Loring Elementary School

Town of Sudbury ADA Transition Plan

January 2021

Figure 1: In the following image, the aqua line indicates the approximate route to the upper basketball court and playground. The blue line indicates the approximate route from the upper to

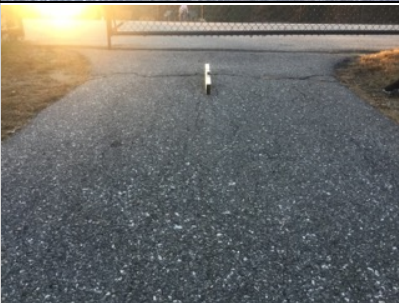
the lower amenities area. The yellow line indicates the approximate location of a new route to the edge of sport activity and team seating at the baseball field. The red line indicates the approximate location of a new route from a cafeteria exit to the future location of the new basketball hoops and the redesigned and rebuilt accessible lower playground. IHCD is including approximate costs to correct issues along the aqua route and for the inclusion of the new yellow route. Sudbury has budgeted for the new red route, the installation of the new basketball hoops, and for the new lower playground. Sudbury also has existing plans to address any excessive slope or other accessibility issues with the blue route and general circulation path between the upper and lower amenities areas.
